## November 2020 BAR Action for 731 Locust Avenue

BAR 20-11-01

731 Locust Avenue

Roof replacement

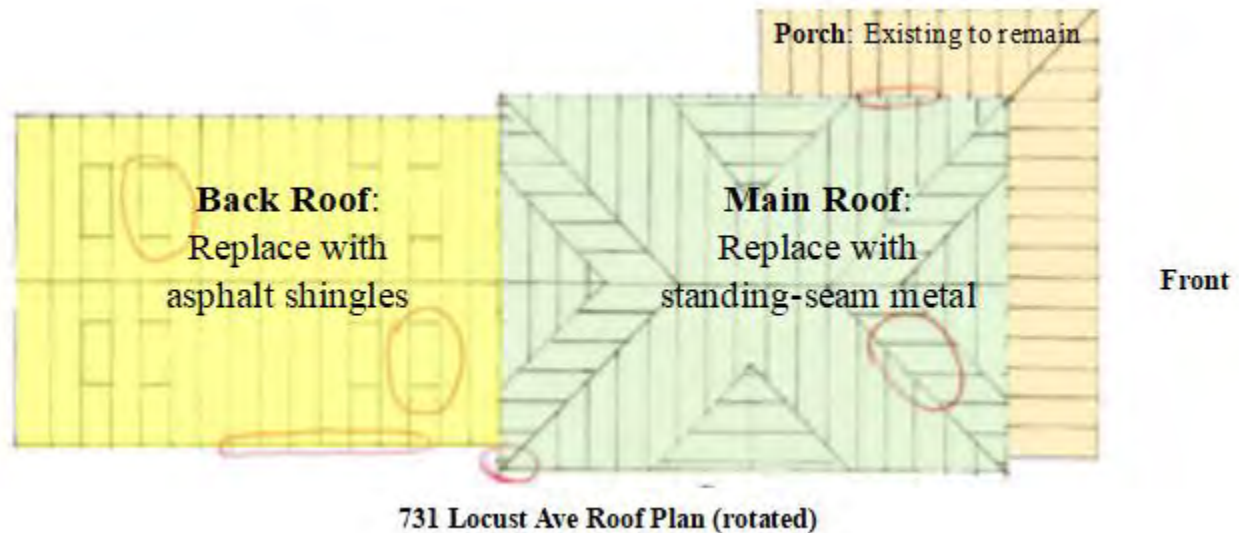
Within Historic Conservation Districts (HCD), a CoA is not required for alterations that are not visible from abutting streets. With that applicable here, staff recommends approval of asphalt shingles on the *back roof* of the house, as noted in the graphic above, which includes the rear portion of the *main roof*.

*Cheri Lewis moves: Having considered the standards set forth within the City Code, including architectural character-defining features for this district, I move to find that the proposed roof replacement, standing-seam metal on the main roof and asphalt shingles on the rear roof, satisfies the BAR's criteria and is compatible with this property and other properties in the Martha Jefferson Historic Conservation District, and that the BAR approves the application as submitted, with a mere suggestion that there be no chunkiness in the ridges.*

731 Locust Avenue Roof description.

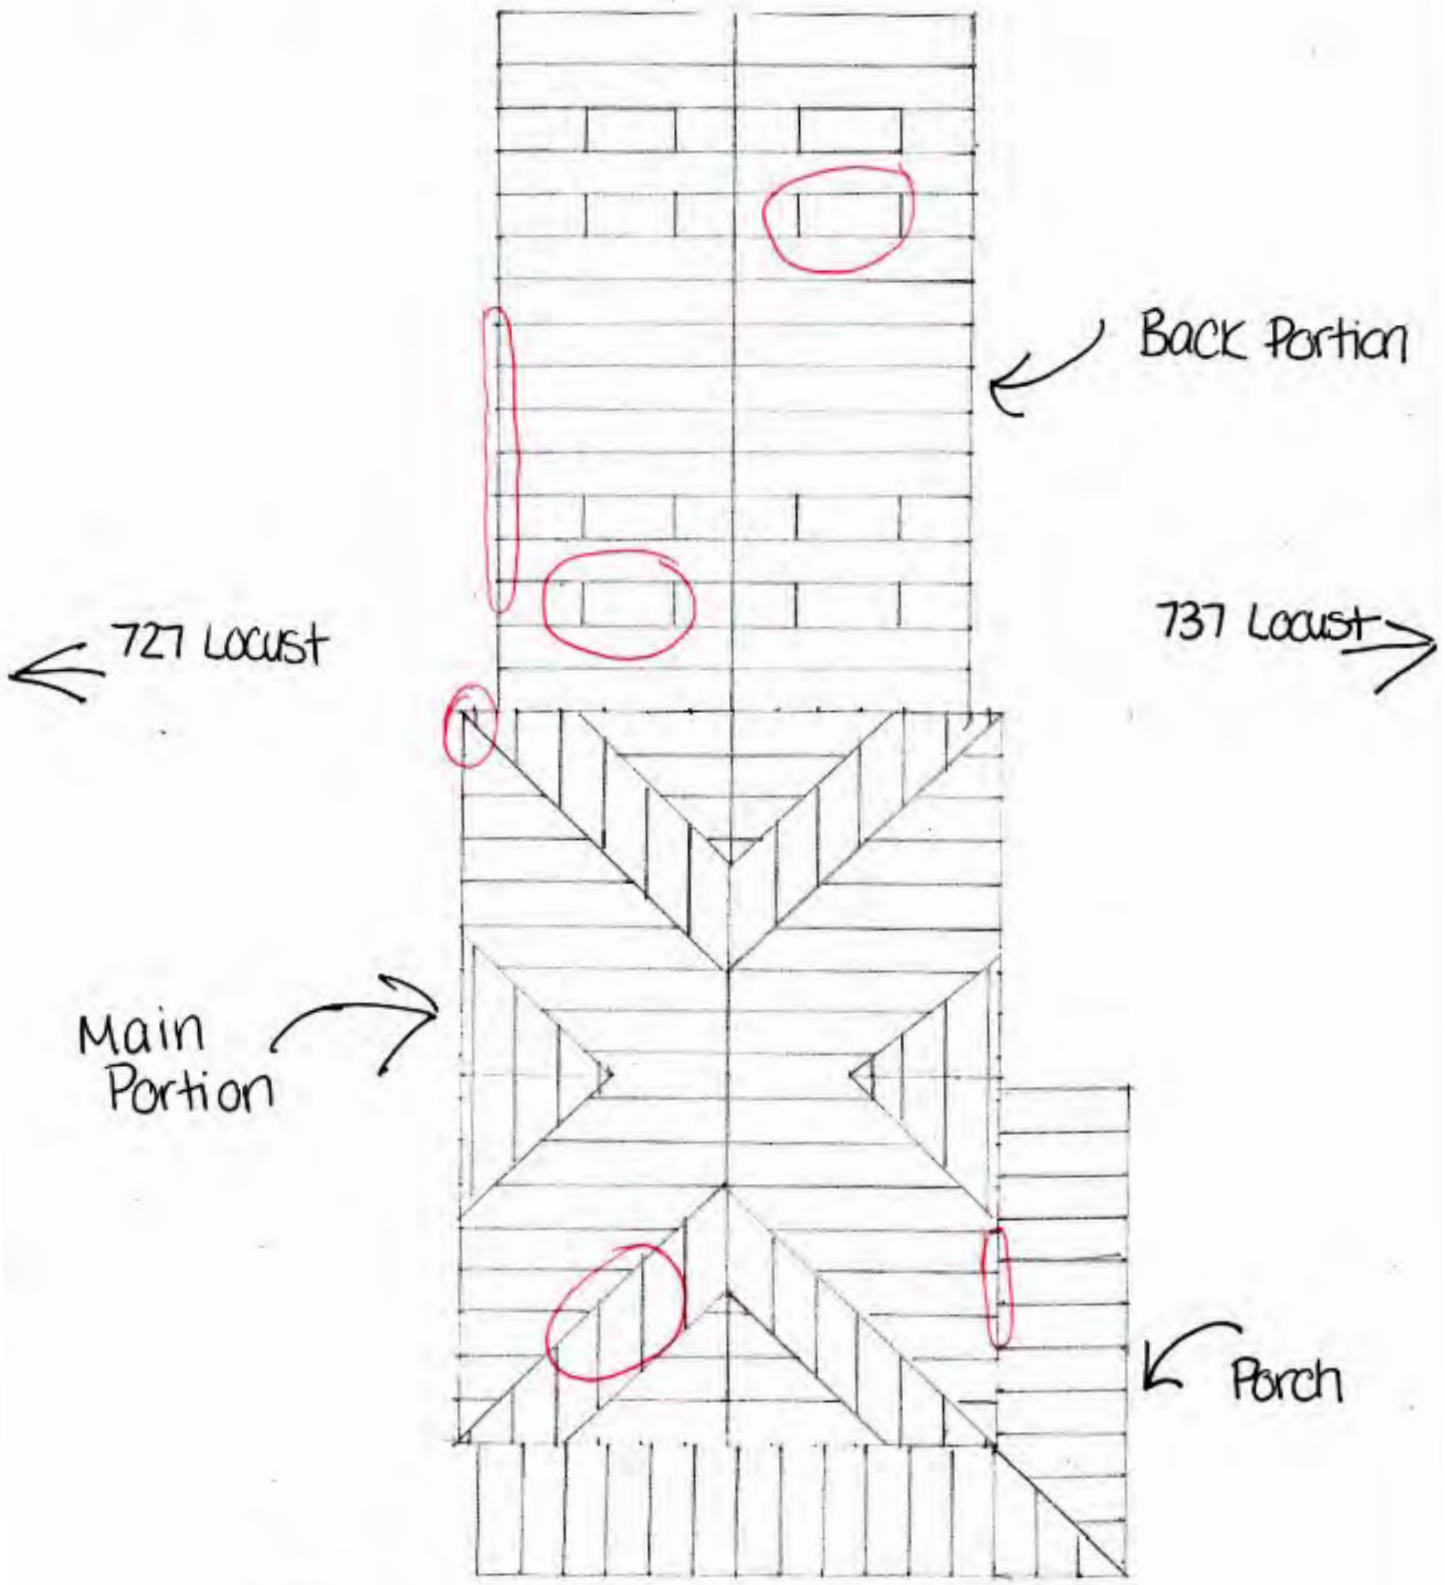
The roof was installed with "single lap" seams opposed to the proper "double lap" seams. Skylights were improperly flashed, as well other flashings about the house. This has created many vulnerabilities, and many long term minor leaks, along with recent larger leaks.

We would like to discuss the possibility of converting the back portion of the house, that is hardly visible from the road to shingles. And the main portion of the house, convert to a non copper standing seam metal roof. For now the front porch will remain a copper roof. Or convert the entire house to shingles.
